**CAPITOL ZONING DISTRICT COMMISSION
STAFF REPORT 2023-018
9/21/23
JCL**

Location: 17th & Scott
Applicant: Cope Gracy for Riverwalk Properties, LLC.
Permit Types: Certificate of Appropriateness

Project Description: The applicant is seeking a Certificate of Appropriates to demolish an existing car wash and construct 12 new, single bedroom townhomes. The proposal is part of a larger development split by the CZDC boundary between Scott and Cumberland Streets, where 12 additional units are proposed. Those units within the CZDC boundary are labeled as Phase 2 on the site plans.

APPROVED	DRAWN BY	DATE	SHEET NO.
	JB	8/07/23	C1
SCALE 1" = 20'

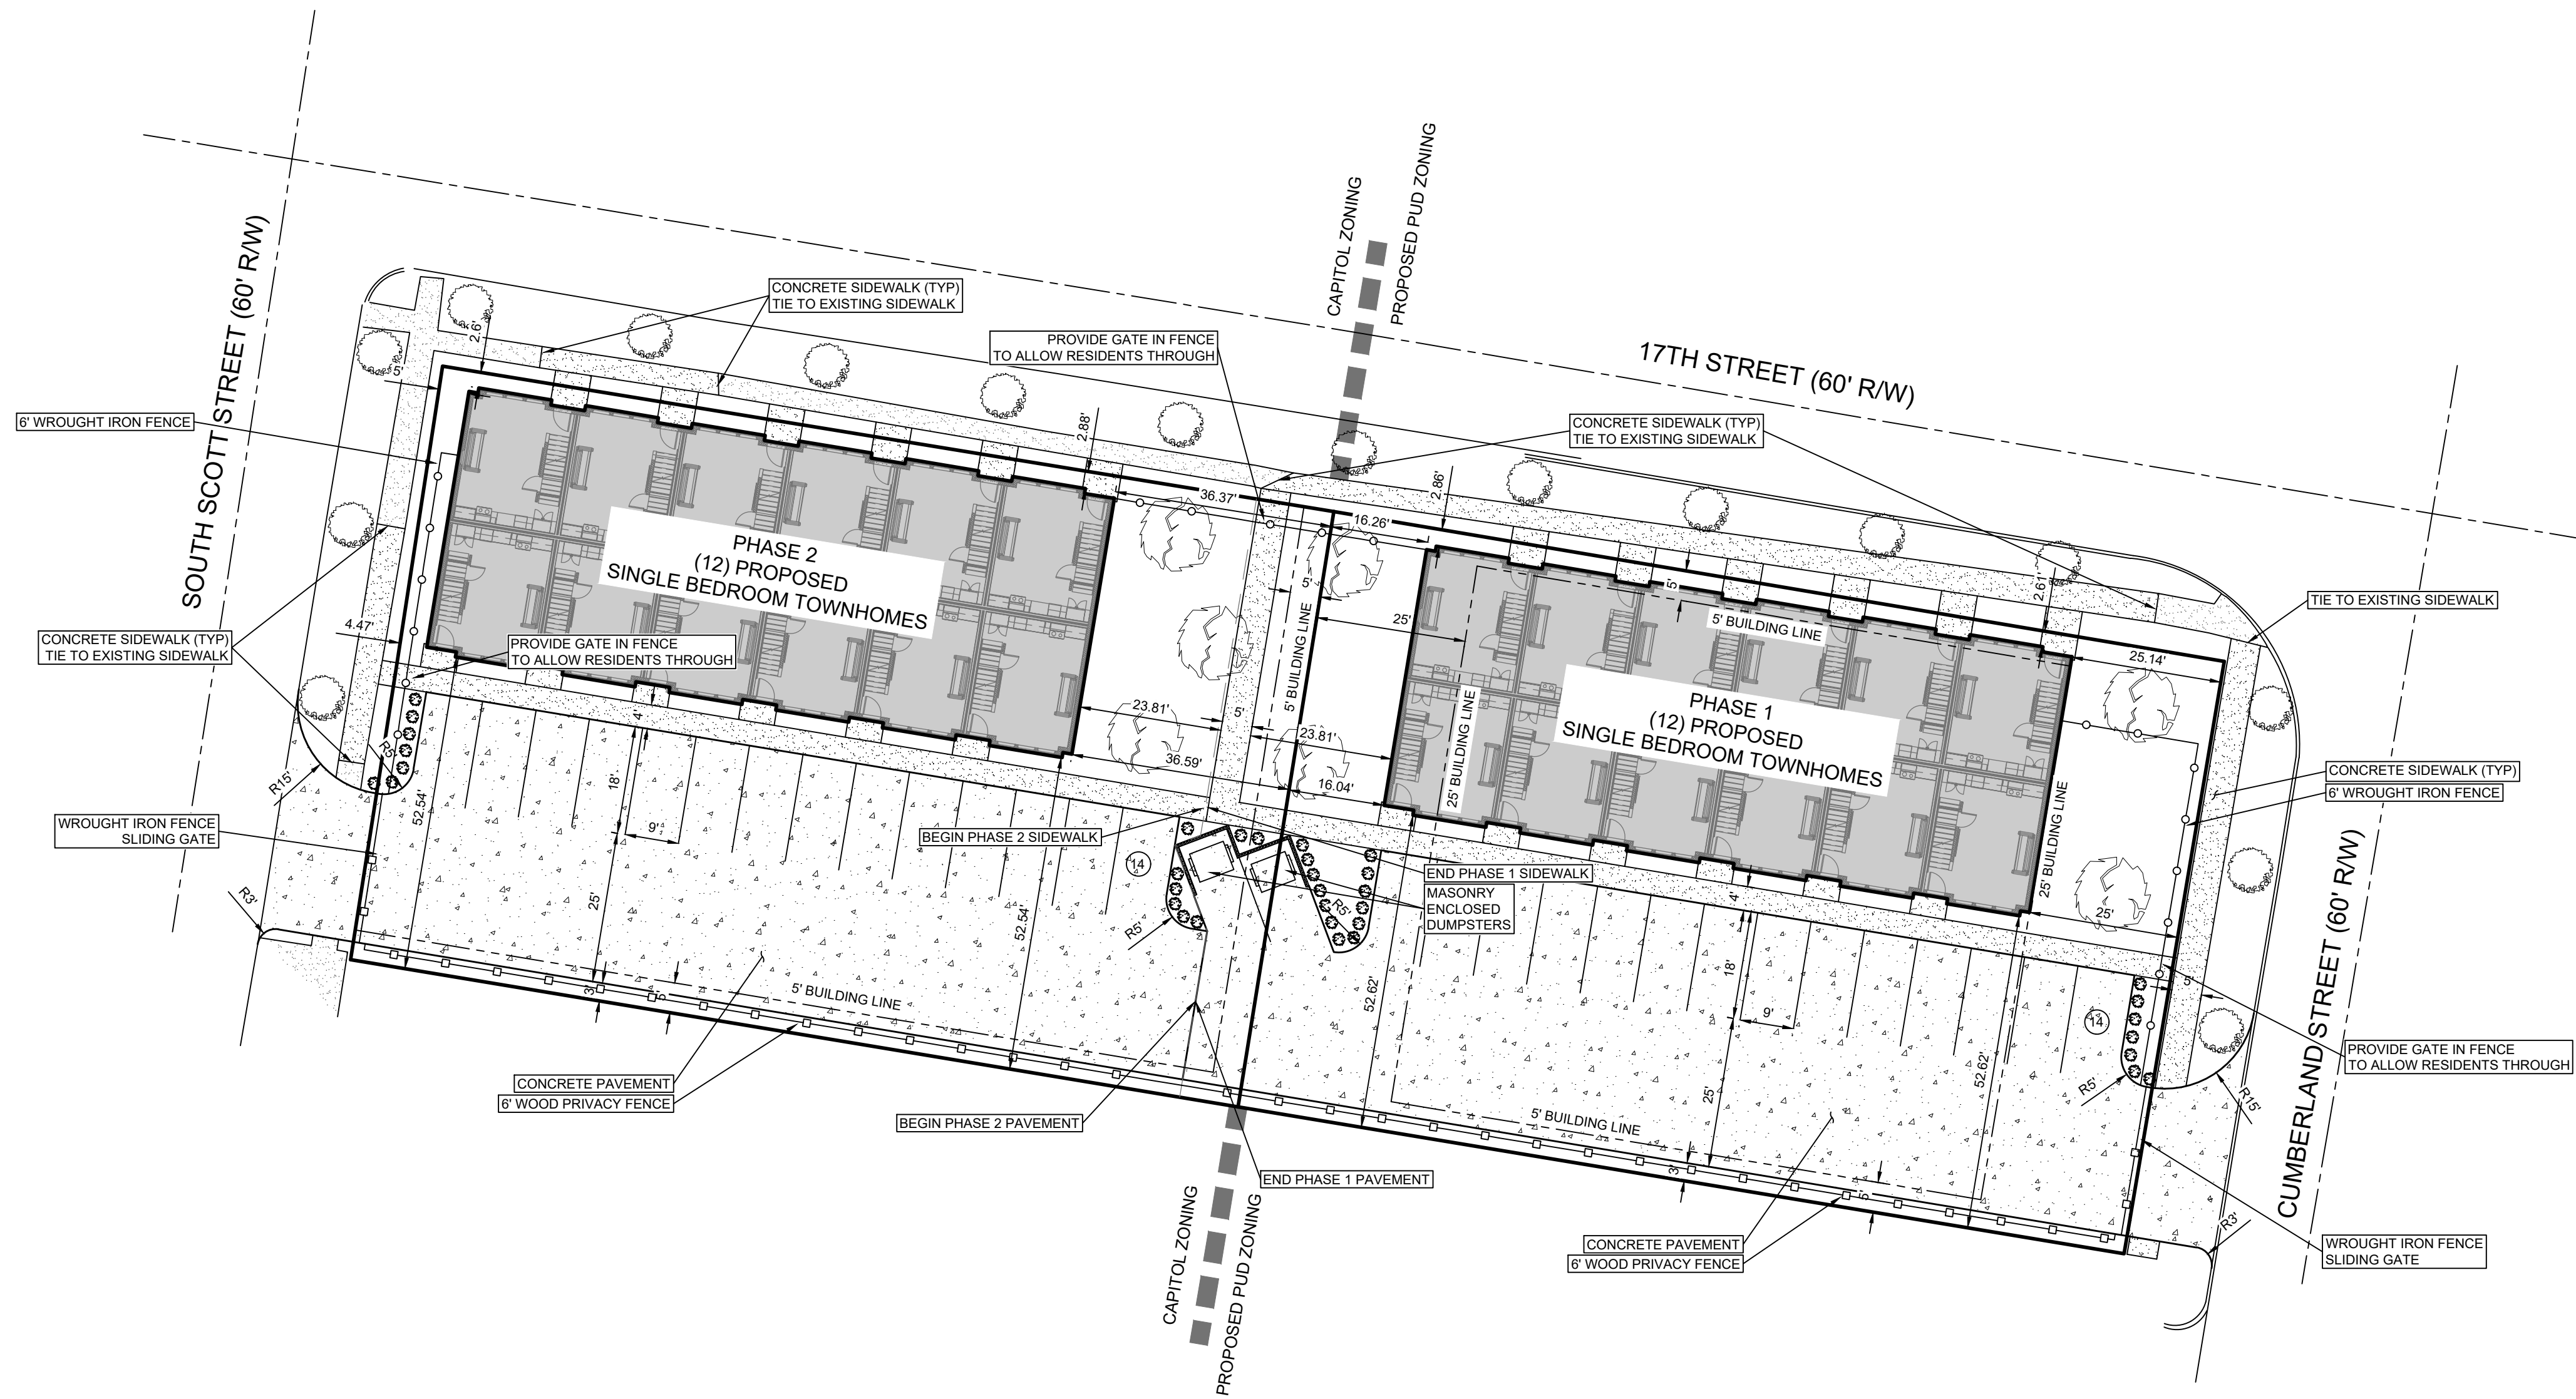
Staff finds the proposal is partially consistent with these standards. Residential 2 (multifamily) includes townhomes. If the front runs along 17th street, the west side setbacks maintain 5 feet from the property line, however the east side is 36 feet. The front setback includes a mandatory build to sidewalk, although staff believes maintaining the proposed 2.5 feet from the property line is more appropriate for this building type. Both would require a waiver of the general side setback standard for Zone O.

Staff finds the landscape plan is consistent with these standards, however specific consideration should be given to the plant species and their location in accordance with the City of Little Rock landscape code. Plantings along 17th street should consider the overhead powerlines as well as the pedestrian experience. Emphasis should also be placed around screening drive-ins and the dumpsters.

Staff finds the proposal for fencing to be partially consistent with these standards and would require a waiver of Standard R1.8. While the rear 6-foot wood privacy fence is appropriate, the 6-foot wrought iron fence located off the structures west façade (corner), is within the setback limit, nor coplanar with the façade of the structure behind it.

Staff Recommendation: Staff recommends **Approval** of a Certificate of Appropriateness to demolish the existing car wash and construct 12 new townhomes. Approval would include a waiver of setback standards for Zone O, and standard R1.8 for fencing with the following conditions:

- 1) That all state and city codes be followed at all times.
- 2) That the property be maintained in a neat and safe condition at all times.
- 3) Phase two parking to include 1 reserved space for the disabled.
- 4) First floor windows shall be divided with surface muntins.
- 5) The peaks of the gables shall contain a vent or brick detail.
- 6) To comply with CZ/ LR landscape requirements.
